16 Stage Coach 100%
of Amherst
Reg
Rd

PLAN OF SEWAGE DISPOSAL SYSTEM	
AT: 16 STAGE COACH RD., AMHERST, MA	
BY: FILIOS ENTERPRISES, INC. 69 PELHAM RD. AMHERST MA 01002 (413)256-8008	FOR: JANICE RATNER 16 STAGECOACH RD. AMHERST, MA 01002
DRAWN BY: P. FILIOS	SCALE: 1" = 30'
REV. #2, 27 JULY, 1994	PAGE 1 OF 2

Re: STATEMENT OF TECHNICAL DEFICIENCY
Application for: BRPWP02
Sewage variance

Re: Variance Request of Leaching System at 16 Stagecoach Road, Amherst

PROFILE OF SEWAGE DISPOSAL SYSTEM

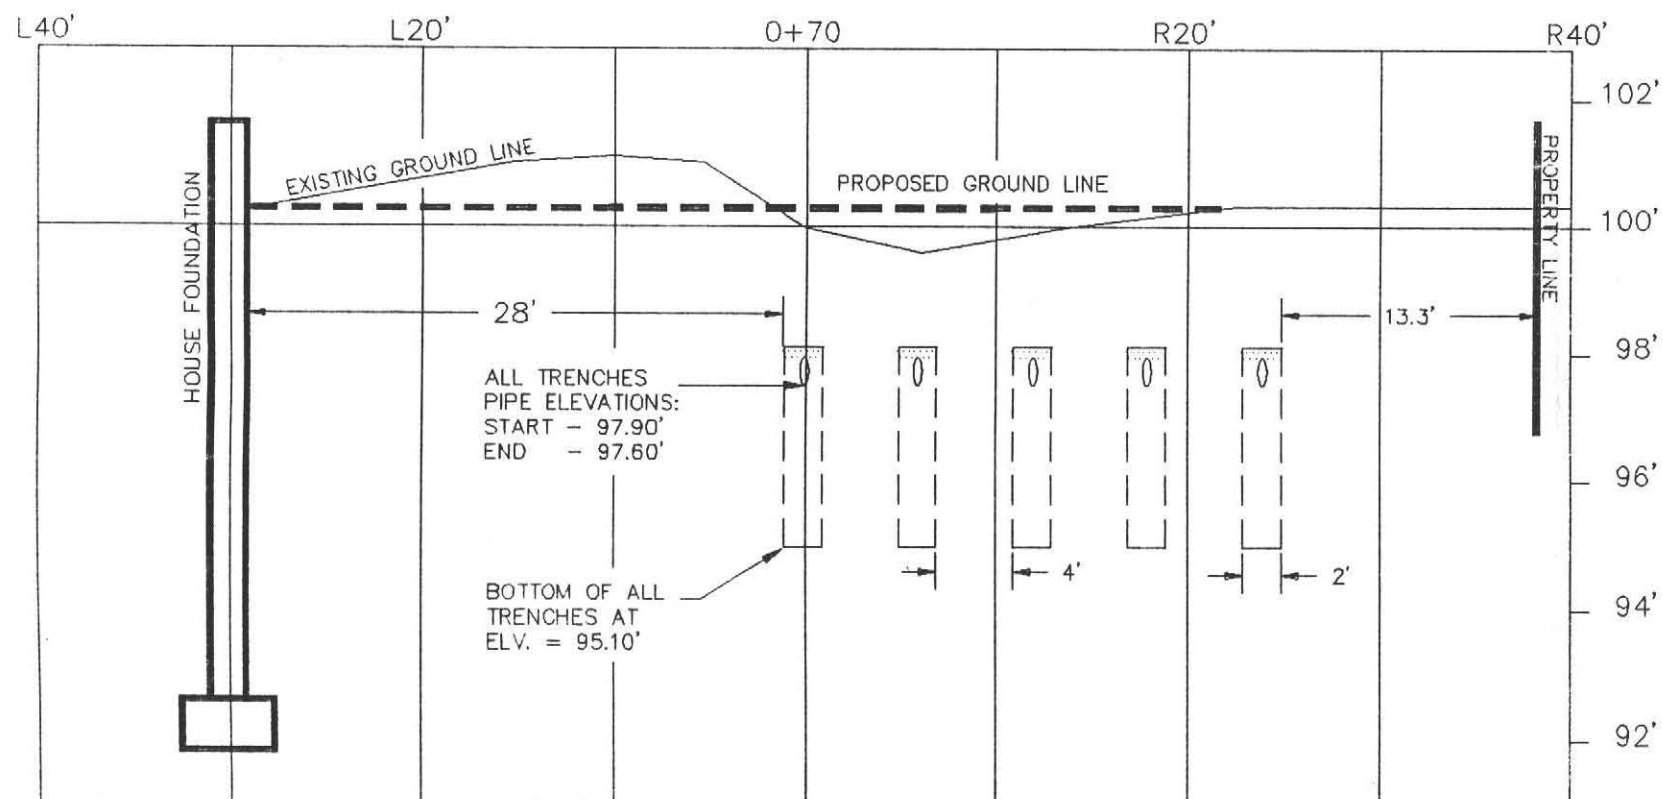
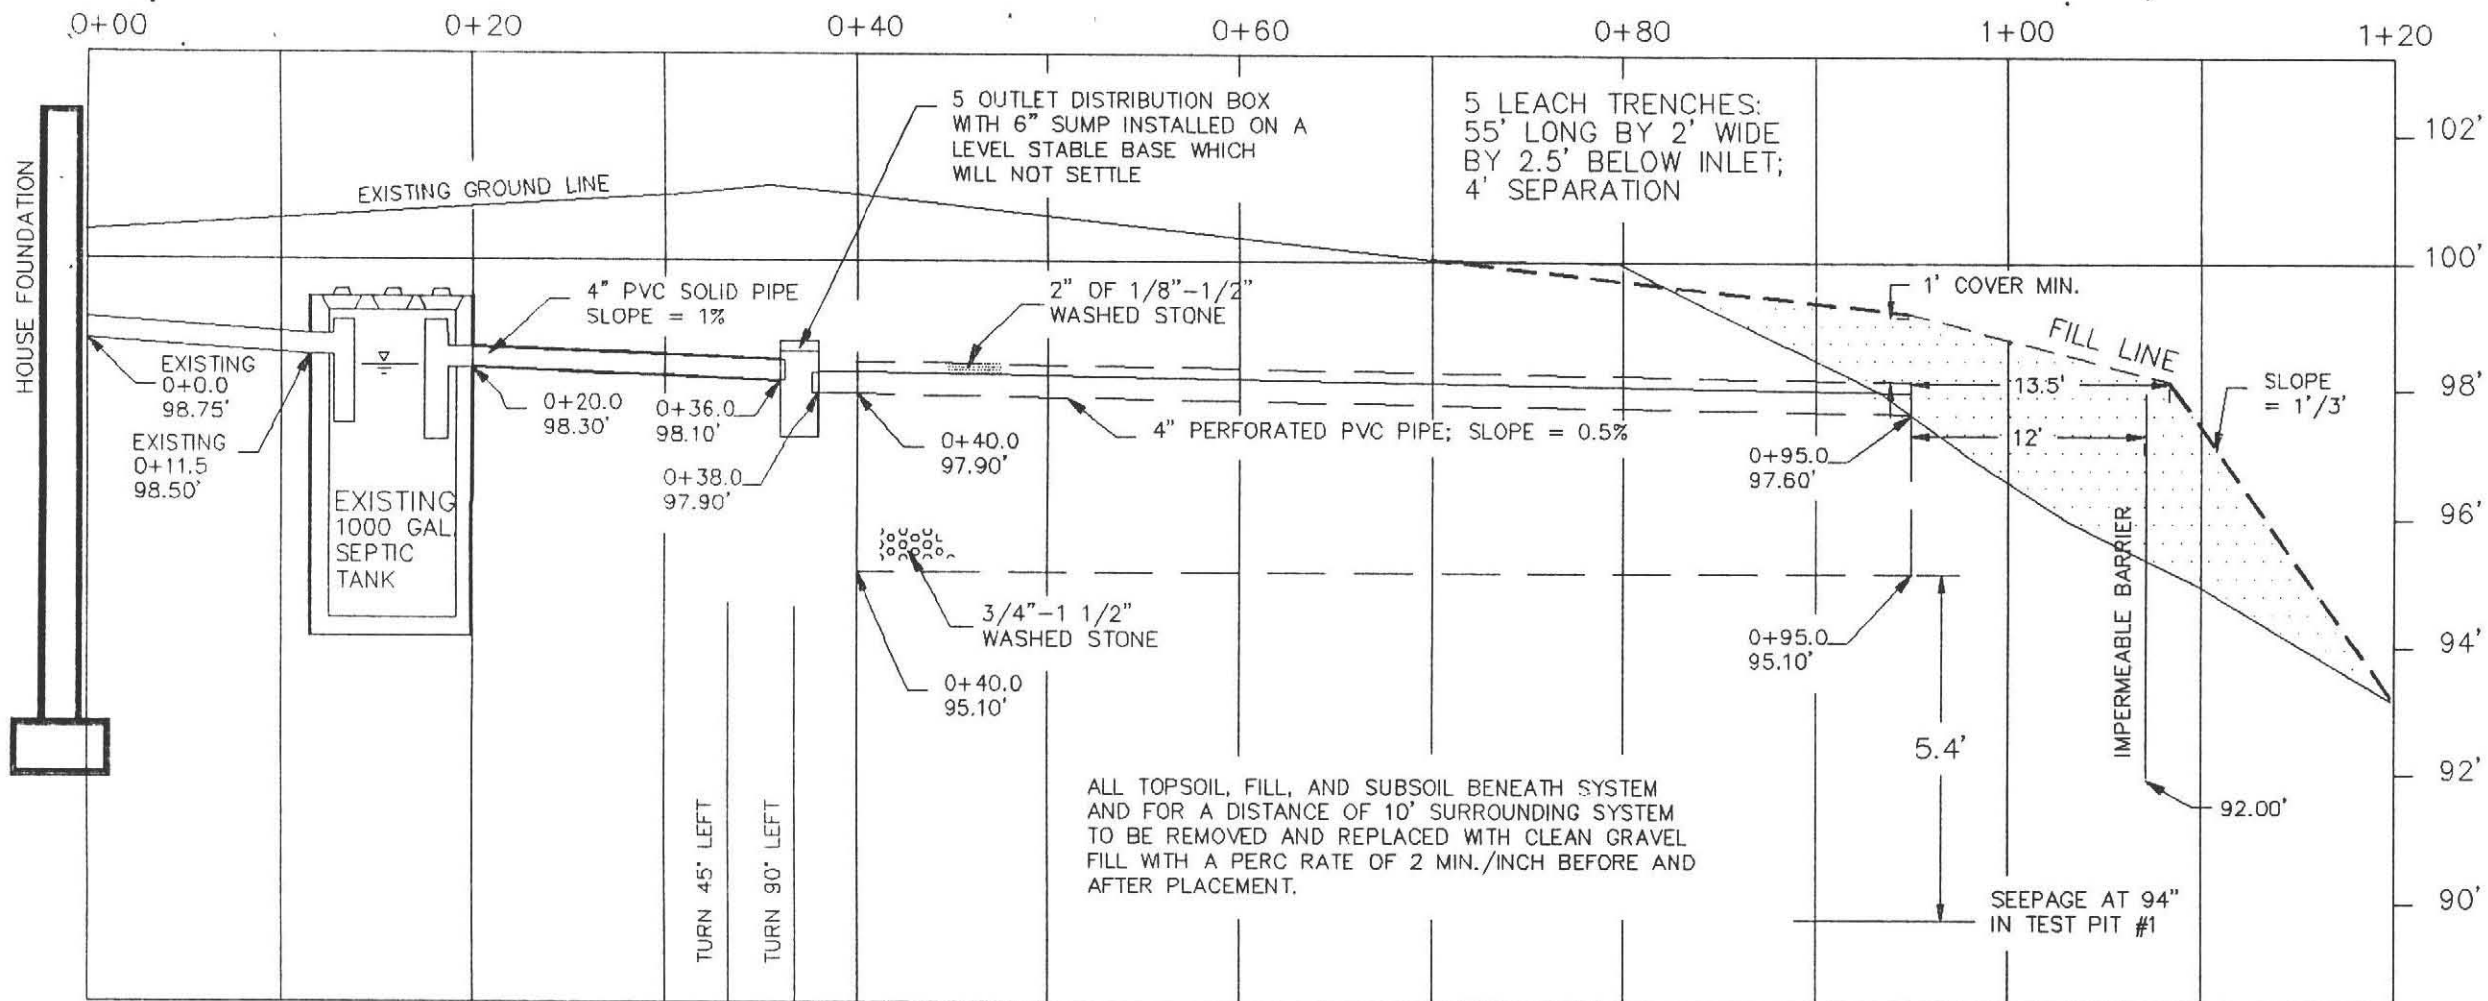
1. A variance request is needed for the perc rate of 37.5 minutes per inch. Under Title V of the State Sanitary Code the allowed rate is thirty (30) minutes per inch (Title V Section 15.03 (4 & 5). Copies enclosed.

At the present time there are no regulations that can be used as a guideline for percolation rates above thirty (30) minutes per inch. In order to meet the requirements of 37.5 minutes per inch Filios Enterprises calculated the number of trenches for the leaching area by extrapolating the bottom and sidewall area in the present code.

2. Title V, Section 15.14 - Leaching Trenches (Figure 1) illustration B, Slope Requirements. The impermeable barrier in lieu of minimum distance required will serve the same function and will allow a steeper fill slope to prevent filling over the existing driveway. Sufficient distance from the trenches is provided in the proposed design to allow adequate area for the treatment and disposal of the leachate. Copies enclosed
3. Town of Amherst (Section 2, A. - Volume of Sanitary Sewer) Requirement of septic system to be designed 25% larger to accommodate the daily flow capacity. The new system will be 10% larger than required by D.E.P. Copy enclosed
